FEDERAL COMMUNICATIONS COMMISSION

In re: W265AT, Springfield, VT
BPFT-20090615ADI
Facility ID # 46339

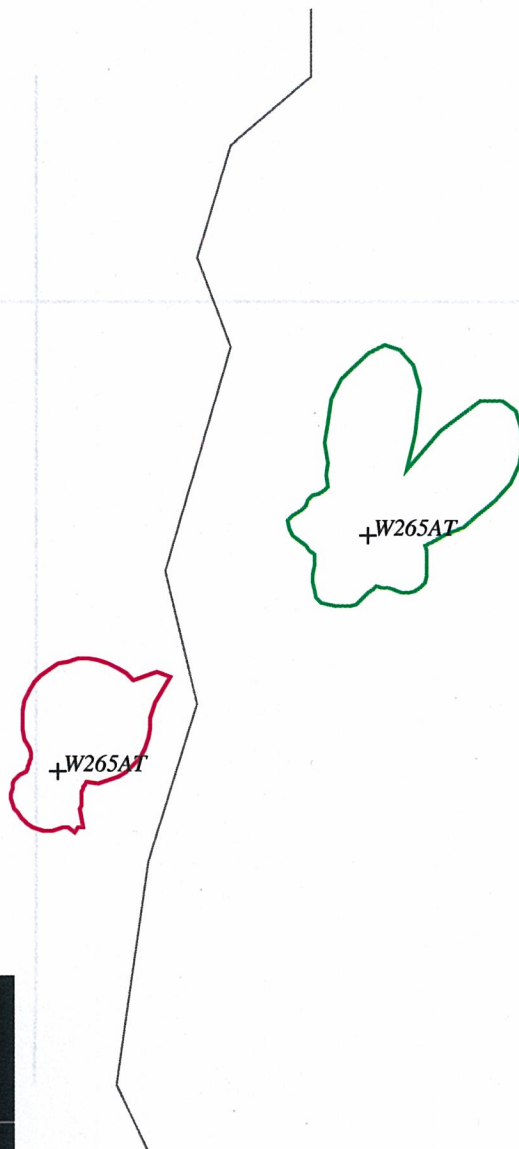
An engineering study has revealed the application is a major change application pursuant to 47 C.F.R. § 74.1233(a)(1). Specifically, the Section states that "a major change is... any change in antenna location where the station would not continue to provide 1 mV/m service to some portion of its previously authorized 1 mV/m service area." The proposed service area would not continue to provide service to some portion BLFT-20090609AAL service area. Because major change applications are not being accepted for filing, we dismiss the application.

In light of the above, the application BPFT-20090615ADI filed by Great Eastern Radio, LLC unacceptable for filing pursuant to 47 C.F.R. § 73.3566(a) and IS HEREBY DISMISSED. This action is taken pursuant to 47 C.F.R. § 0.283.

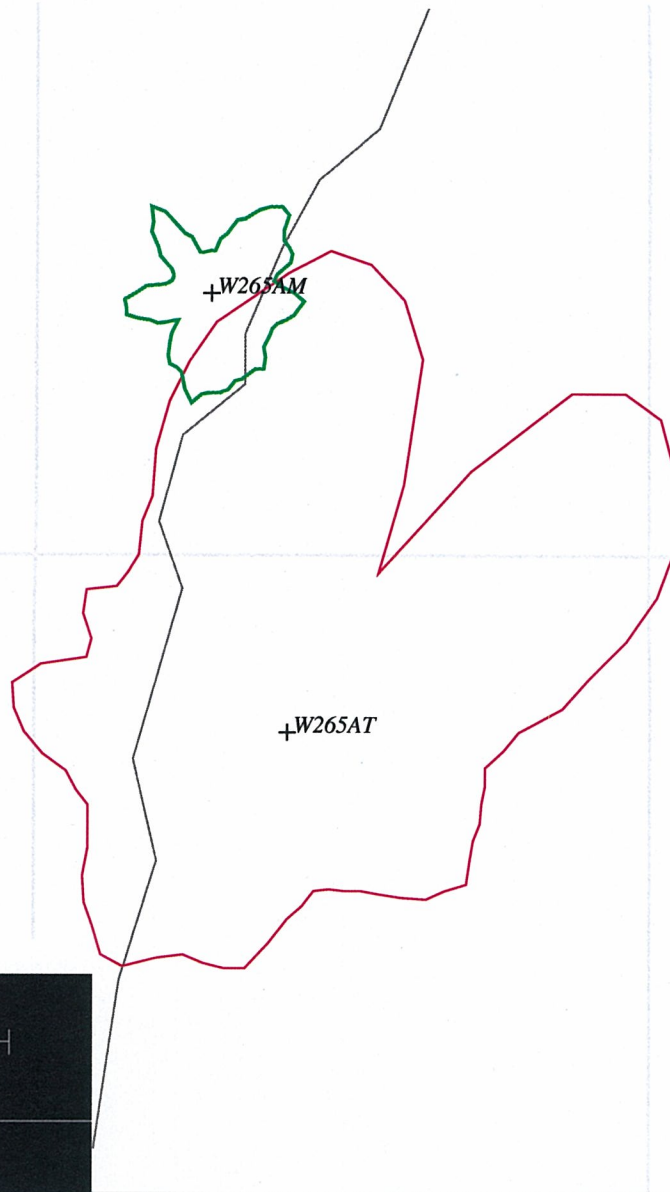
Secondly, the engineering study has revealed the application violates 47 C.F.R. § 74.1204(a) with respect to W265AM, Norwich West Lebanon, Vermont (BLFT19881014TB). Section 74.1204(a) states that an application for a FM translator station will not be accepted if the proposed operation would involve prohibited overlap of predicted field strength contours with any other authorized station. The proposed 40 dBu interference contour would overlap the 60 dBu protected contour of W265AM. The application failed to discuss this violation.
